Beaver Valley Power Station, Unit No. 1
Docket No. 50-334, License No. DPR-66
Response to Request for Additional Information on the ASTRUM Best-Estimate
Large-Break Loss of Coolant Accident (LOCA) Methodology License Amendment Request
(TAC No. ME1776)

Response to January 26, 2010 Request for Additional Information - License Amendment
Request for ASTRUM Best-Estimate Large-Break Loss-of-Coolant Accident (LOCA) Methodology

Response to January 26, 2010 Request for Additional Information
License Amendment Request for ASTRUM Best-Estimate Large-Break
Loss-of-Coolant Accident (LOCA) Methodology
Page 1 of 9

Figure 2.1

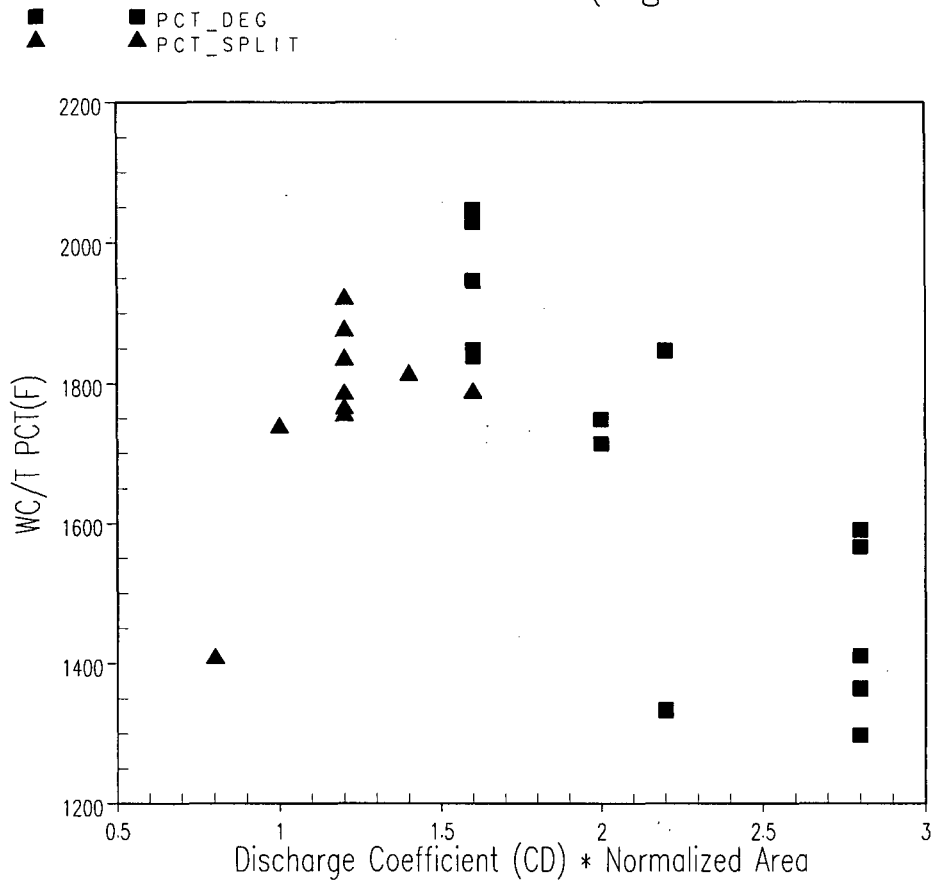
2. For the current AOR (Code Qualification Document (CQD) method), provide a scatter plot of PCT vs. break characteristics (normalized area and discharge coefficient) that distinguishes between slot breaks and double-ended breaks.

Figure 2.1 presents the results in terms of WCOBRA/TRAC-calculated PCT of cases from the BVPS-1 CQD analysis of the double-ended cold leg guillotine (DECLG), and slot (split) breaks. A normalized area (Break Area/Cold Leg Area) of 2.0 applies to guillotine breaks, and a normalized area of 1.0 applies to slot breaks. In the CQD methodology, the discharge coefficient (CD) sensitivity study is performed first for the split break to determine the limiting break size. Once the limiting split break CD is determined, the augmented split break matrix is performed with variation in broken cold leg nozzle resistance and downcomer condensation multiplier. The response to RAI item 6 contains additional details.
